Dogger Bank South Offshore  
Wind Farms

Project Change Request 2 – Onshore Substation  
Zone

Document Reference: 10.53

Revision Number: 01

**DRAWING TITLE**  
**FIGURE 1 (b) - INDICATIVE GENERAL ARRANGEMENT DRAWINGS FOR THE ONSHORE CONVERTER STATION(S) - PROPOSED CHANGE**

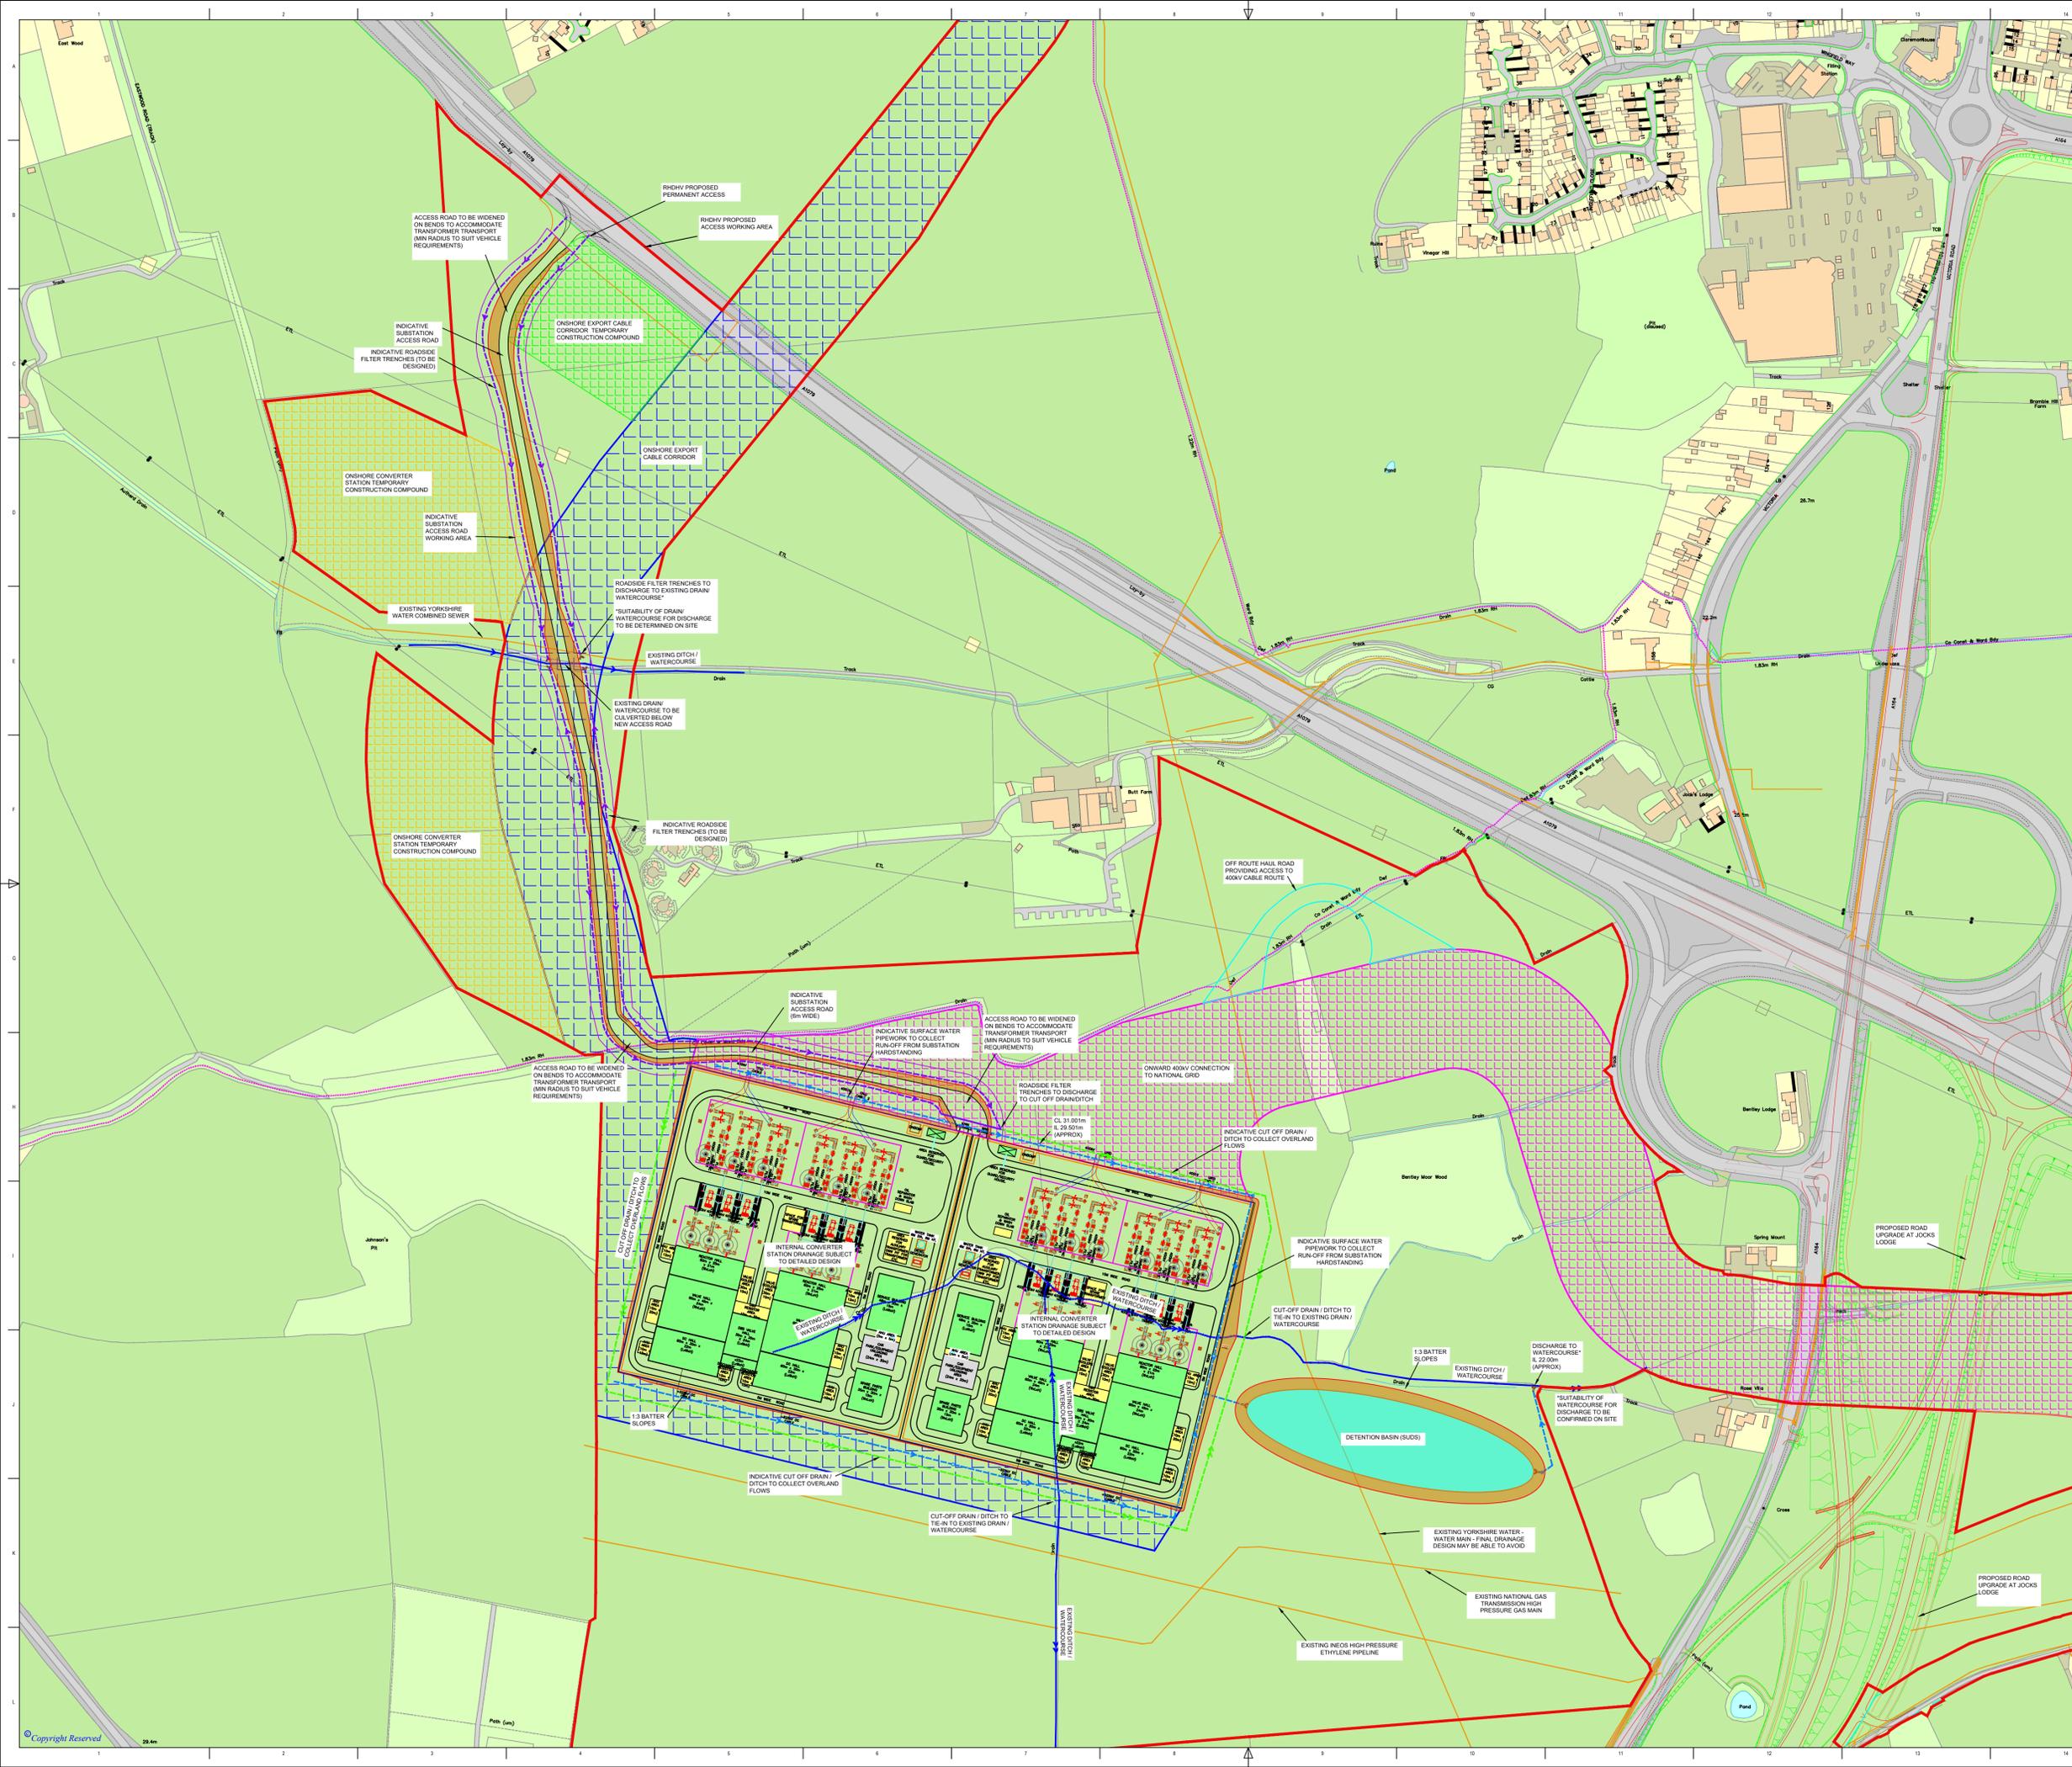
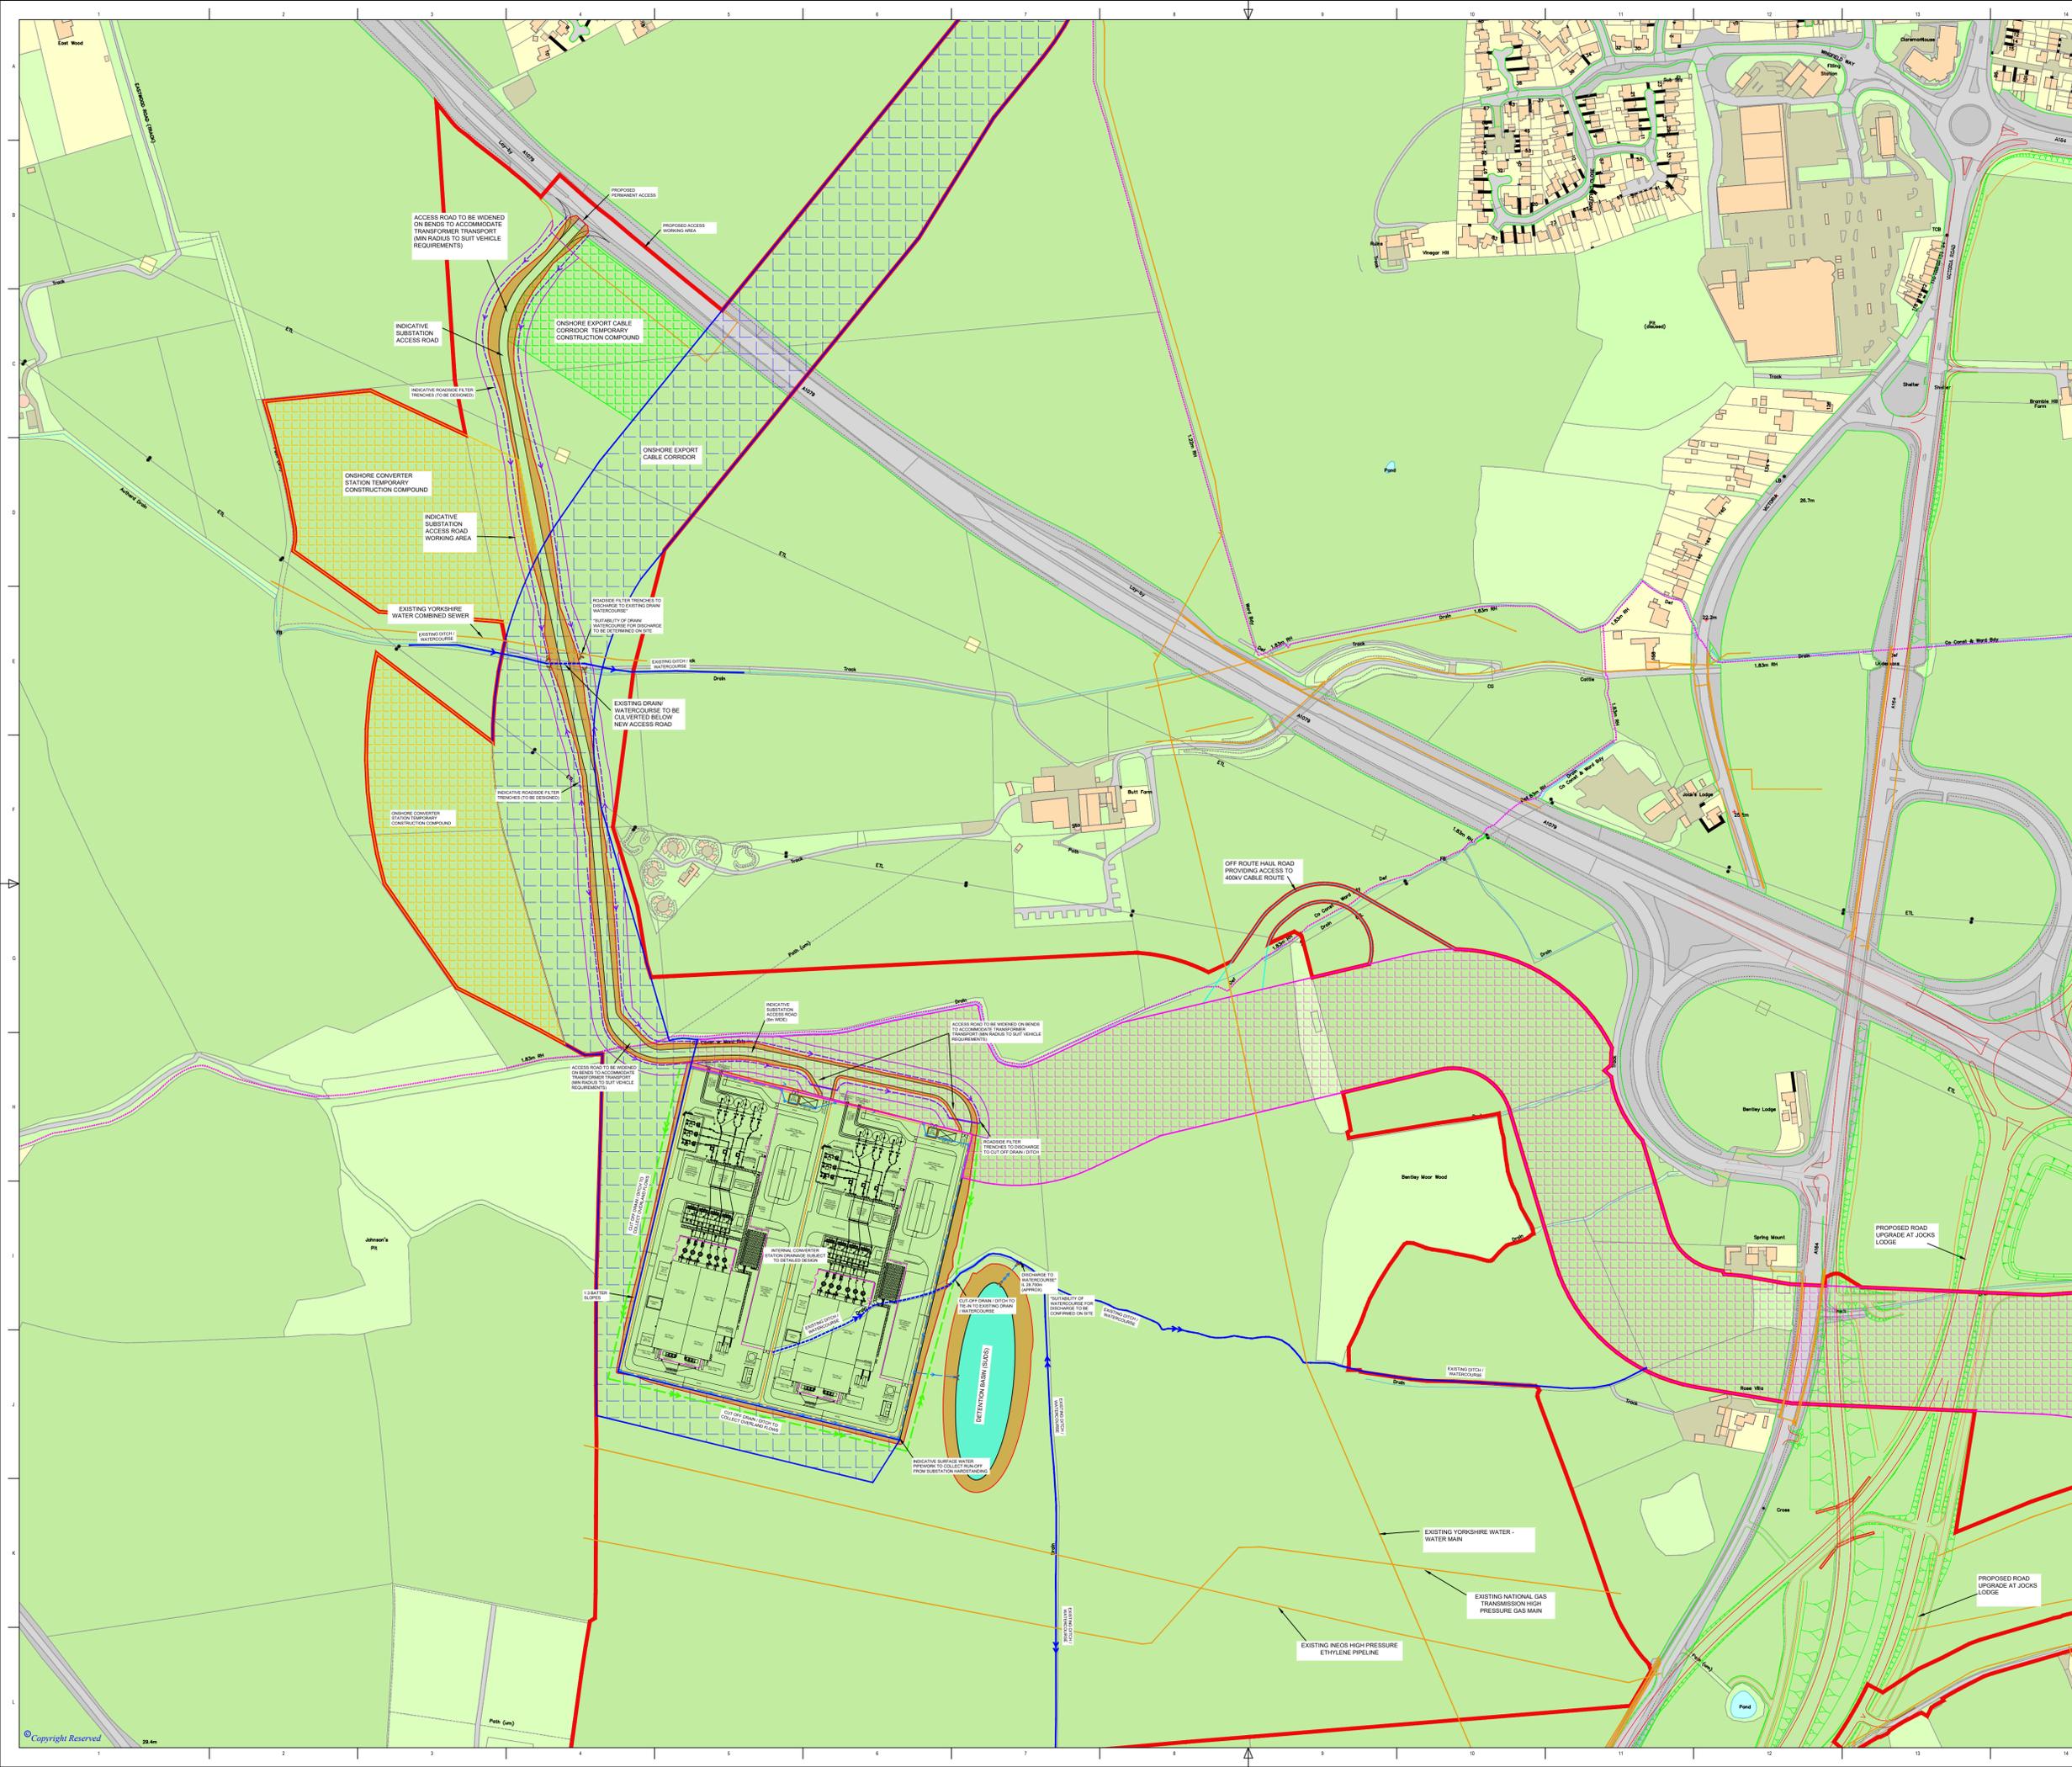
11. The proposed reduction in the footprint of the Onshore Converter Station(s) shown in Figure 1 (b) would result in a number of minor associated amendments within the Onshore Substation Zone as listed below:

- Minor updates to the Indicative Landscape Plan at the Onshore Substation Zone as presented on Figures 2(a) and 2(b) (Appendix A);
  - Reduction in size and change of indicative location of Sustainable Drainage System (SuDs) requirements as presented on Figures 1(a) and 1(b) (Appendix A);
